COMMITTEE OF ADJUSTMENT REPORT SUMMARY MINOR VARIANCE APPLICATION FILE NUMBER A047/23 310 WOODGATE PINES DRIVE, KLEINBURG

COMMITTEE OF ADJUSTMENT REPORT MINOR VARIANCE APPLICATION A047/23

310 WOODGATE PINES DRIVE, KLEINBURG

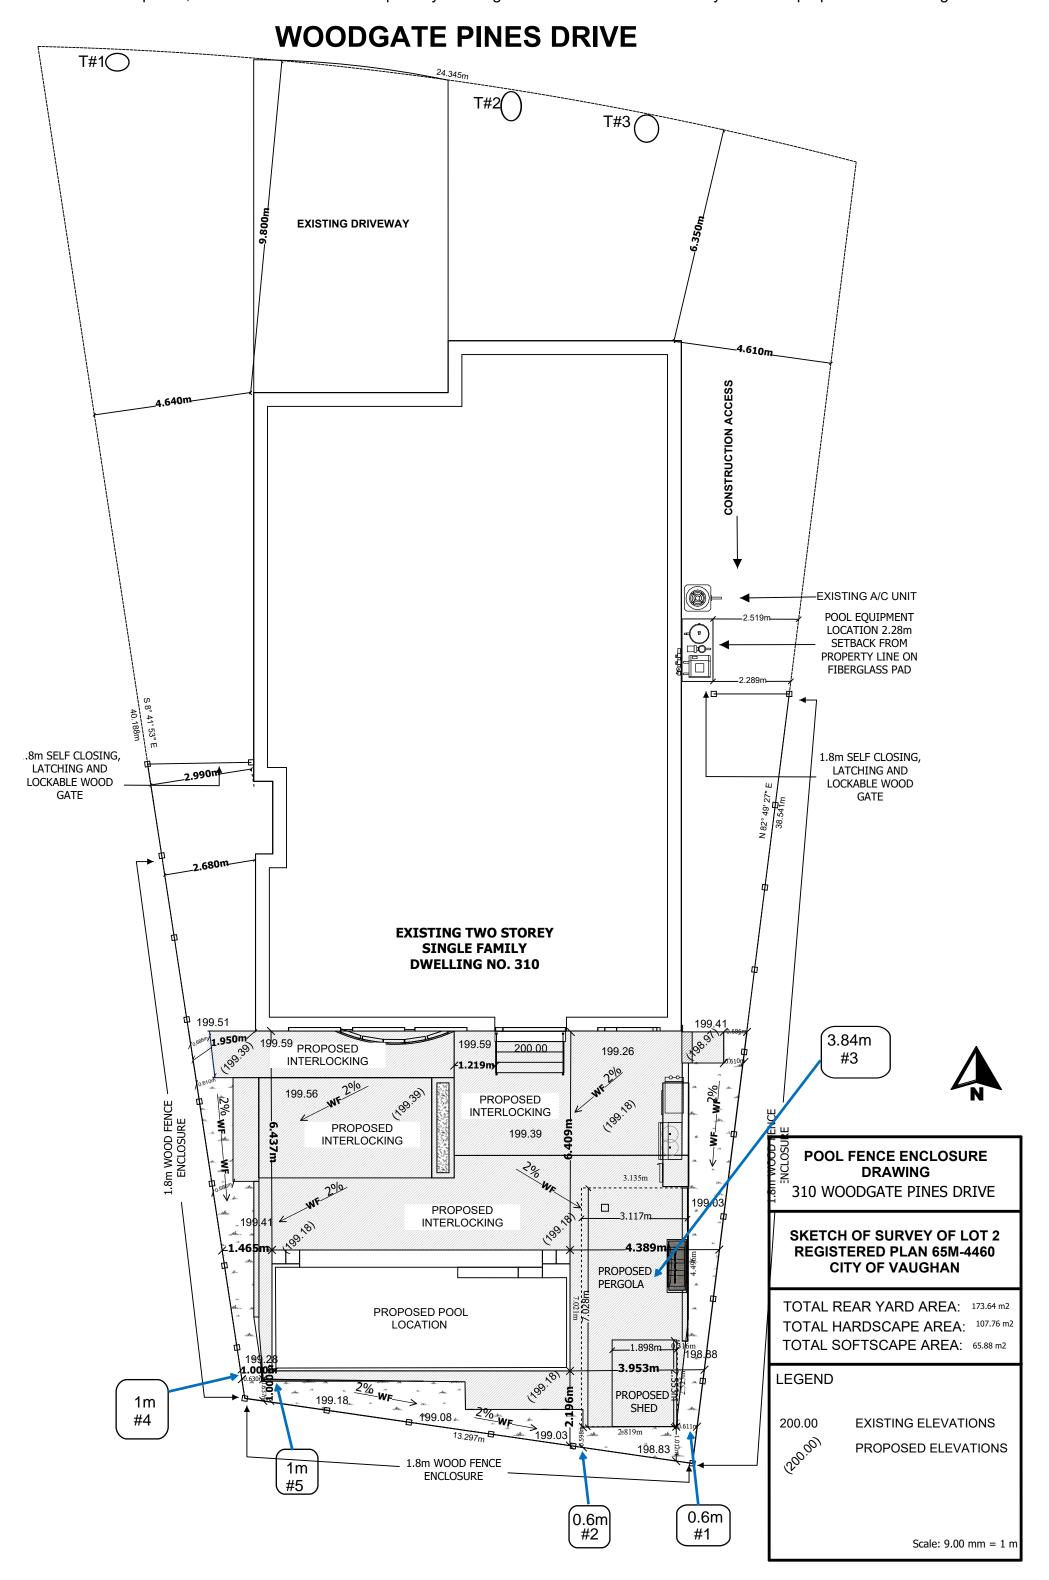
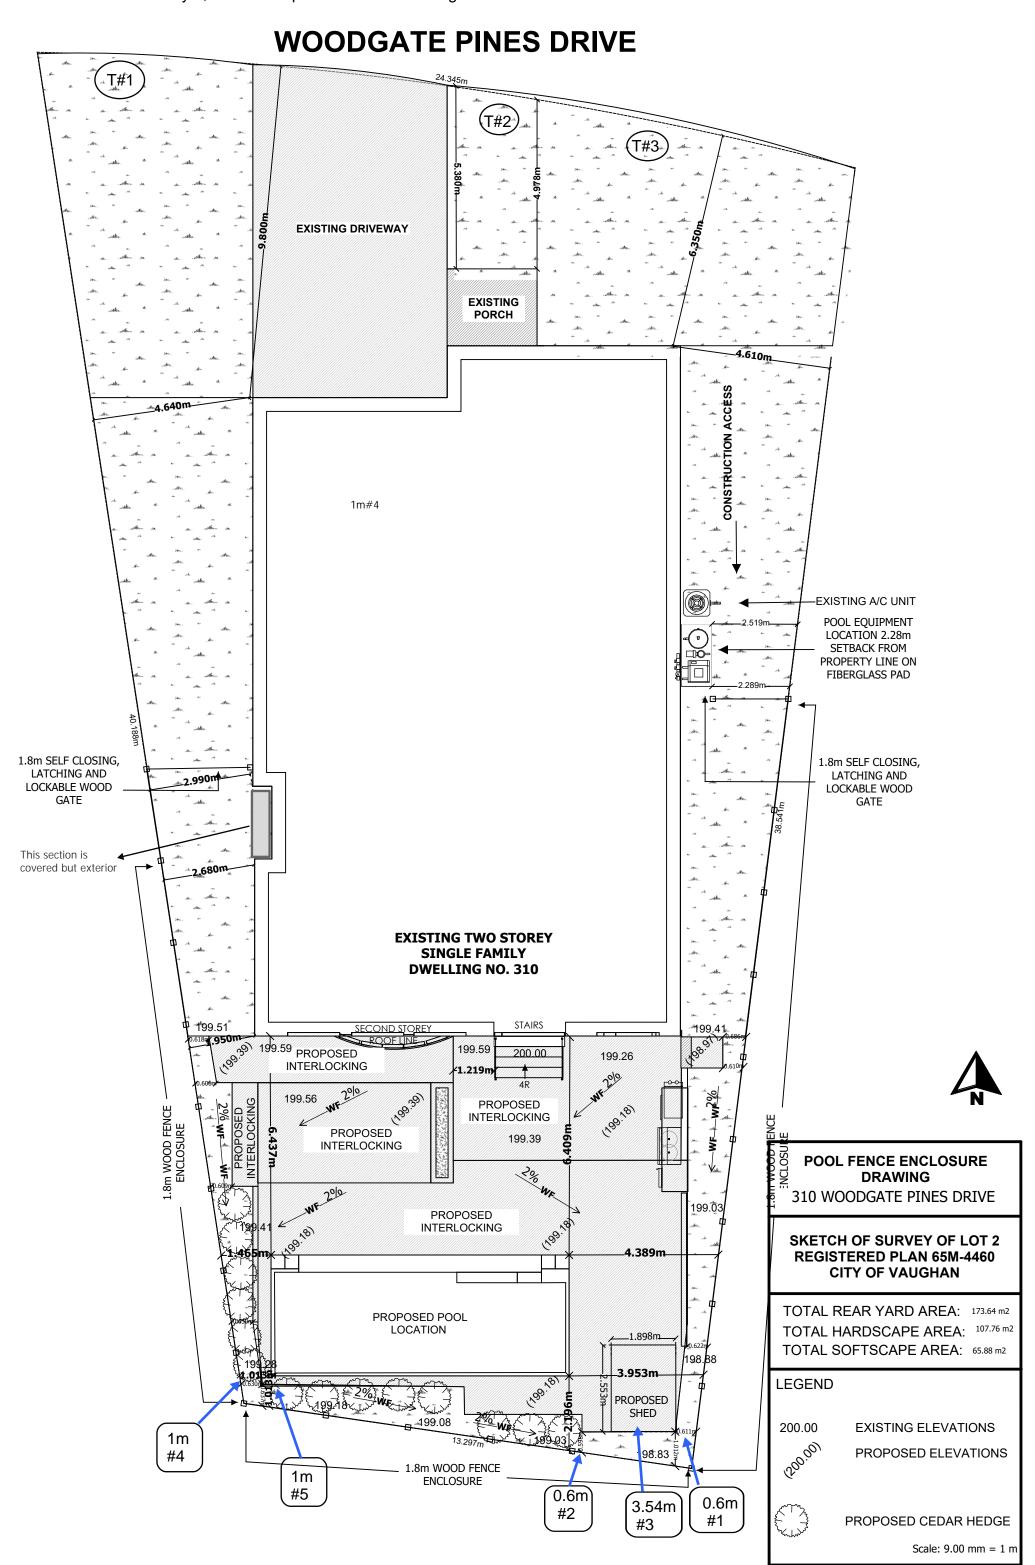
COMMITTEE OF	ADJUSTMENT COMMENTS
Date Public Notice Mailed:	April 27, 2023
Date Applicant Confirmed Posting of Sign:	April 21, 2023
*As provided by Applicant in Application Form Adjacusement Basewage (from atoff):	The design vision of our family for enhanced outdoor living, covered shade space, and needs for a large family's pool use and enjoyment does not allow to conform to the requirements of the Zoning Bylaw. Each space is versatile and caters to different times of the day and to different ages using the space. This will allow our family endless hours of fun and entertainment so that we can maximize the usable space to enjoy and connect with our friends and family outdoors.
Adjournment Requests (from staff): *Adjournment requests provided to applicant prior to issuance of public notice	On April 26, 2023, Development Planning provided the following:
	Development Planning has completed our full review of the above noted minor variance application. We recommend reducing the height and length of the pergola to mitigate the massing impacts the structure will have on the surrounding properties, as we are unable to support the structure as currently shown. Our Urban Design division have also provided similar comments/recommendations attached. Please address these comments as much as possible. Development Planning will also require the below revisions to the Site Plan and clarification about the proposal. 1. Please clarify the dark grey rectangle that is un-

labelled on the site plan. 2. Can the pergola slat roof be closed? This may make a difference in the lot coverage calculation. 3. The pergola and shed appear to be the same height but have different angles to their sloped roofs. Please clarify if this is an error as it does not seem possible for this to be the case if the shed is located under the pergola. 4. Denote the covered porch, stairs and any/all walkways on the site plan. 5. The indentation in the west wall on the first floor appears to be under a porch as the second floor runs straight across. Please denote this on the site plan as it may be counted towards lot coverage. On May 1, 2023, applicant submitted Zoning Review Waiver, reducing height of pergola/cabana from 3.84m to 3.54m.

COMMITTEE OF ADJUSTMENT COMMENTS On May 2, 2023, applicant provided a revised plan addressing urban design comments (the site plan has been adjusted to incorporate the cedar hedge trees near fence). On May 2, 2023, Committee of Adjustment staff provided: Please be advised that the attached plan has not been reviewed by zoning staff. Given that you have submitted a zoning review waiver, confirming variances not being changed, the plan will be provided to the Committee. Should additional variances be determined at the Building Permit stage, a new submission would be required. Was a Zoning Review Waiver (ZRW) Form submitted by Applicant: Yes *ZRW Form may be used by applicant in instances where a revised submission is made, and zoning staff do not have an opportunity to review and confirm variances prior to the issuance of public notice. *A revised submission may be required to address staff / agency comments received as part of the application review process. *Where a zoning review has not been completed on a revised submission, an opportunity is provided to the applicant to adjourn the proposal prior to the issuance of public notice. In accordance with Procedural By-law 069-2019, an Adjournment Fee is applicable to reschedule an application after the issuance of public notice where a request for adjournment has been provided to the applicant prior to the issuance of public notice. An Adjournment Fee can only be waived in instances where adjournment of an application is requested by the Committee or staff after the issuance of public notice. **Committee of Adjustment Comments:** None Committee of Adjustment Recommended None **Conditions of Approval: BUILDING STANDARDS (ZONING) COMMENTS** **See Schedule B for Building Standards (Zoning) Comments **Building Standards Recommended** None **Conditions of Approval: DEVELOPMENT PLANNING COMMENTS** **See Schedule B for Development Planning Comments. **Development Planning Recommended** None **Conditions of Approval:** DEVELOPMENT ENGINEERING COMMENTS

Upon recommendations from the Development Planning Department, the Owners have revised their application to decrease the height of the shed. The Development Planning Department has no objection to Variances 1, 2 and 3 for the revised proposed shed. The 0.54 m increase in height for the shed is not anticipated to pose adverse use or massing impacts to the neighbouring properties. The reduction to the rear and interior side yard setbacks are measured at pinch points that expand to approximately 1.01 m and 0.92 m respectively. As such, the shed will not pose adverse massing and privacy impacts to the neighbouring properties and an appropriate area for maintenance access is maintained. The Development Engineering Department has also reviewed the proposal and is satisfied that drainage in the rear yard will be maintained.

The Development Planning Department has no objection to Variances 4 and 5 for the proposed pool. The requested setbacks are measured at a pinch point so the full extent of the requested relief will only be utilized by the southwest corner of the pool. The applicant has also proposed hedges along the length of the pool to provide screening. As such, the reduction to the rear and interior side yard setbacks are minor in nature, will not have adverse impact to the neighbouring properties, and maintain an appropriate area for safe access and maintenance.
